**REPLACING PAGE ADDENDUM**

**RECORDER-REPRODUCERS**  
**KS-12068 L4, L5, L6, AND L7**  
**REQUIREMENTS AND ADJUSTING PROCEDURES**

**1.001** This addendum supplements Section 034-351-701, Issue 7. The attached pages must be inserted in the section in accordance with the filing instructions above.

**2.002** This addendum is issued to replace SF-96-500 silicone fluid with SF-1147 silicone fluid.

**Fig. 1—KS-12068 Recorder-Reproducer—Front View with Cover Removed—L6 Machine Shown Equipped with Recording Band Wiper-Lubrication Assembly**

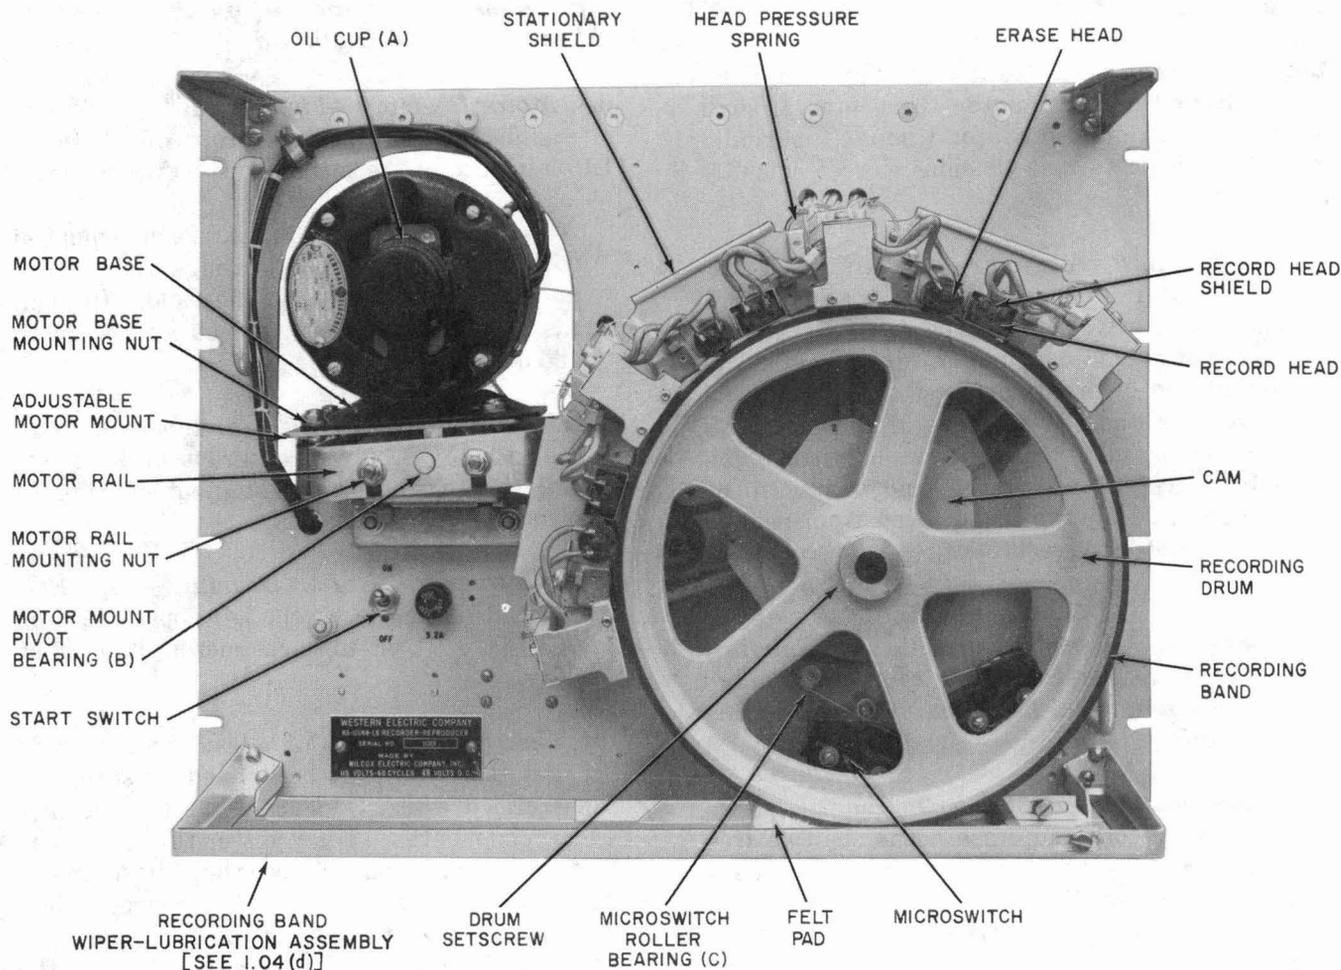
(e) **Recording Band—Fig. 1:** On machines not equipped with a recording band wiper-lubrication assembly, ◆SF-1147◆ silicone fluid lubricant shall be applied to the recording band at least once a month in accordance with the procedure described in 3.01(c). The band shall be sufficiently lubricated when the entire recording surface area is uniformly wet and shiny. Periodic manual lubrication of recording bands is not required on machines equipped with a recording band wiper-lubrication assembly. The felt wiping pad (Fig. 1) and the silicone fluid in the reservoir (slide) on the wiper-lubrication assembly should be inspected once monthly to ensure that the fluid is free of visible contamination. Proper positioning of the wiper-lubrication assembly shall be maintained so that the felt wiping pad fits snugly with **light pressure** against the magnetic recording

(e) **Recording Band—Fig. 1:** Lubrication of recording bands on machines not equipped with a recording band wiper-lubrication assembly shall be in accordance with the procedure described in 3.01(c). Machines equipped with a recording band wiper-lubrication assembly (Fig. 1) shall be adjusted to provide continuous lubrication to the band. Adjust the wiper assembly so that the felt wiping pad makes proper contact with the recording band.

(3) If the wiping pad appears to contain an insufficient amount of  $\blacklozenge$ SF-1147 $\blacklozenge$  silicone fluid, additional fluid may be added in accordance with 2.02(e).
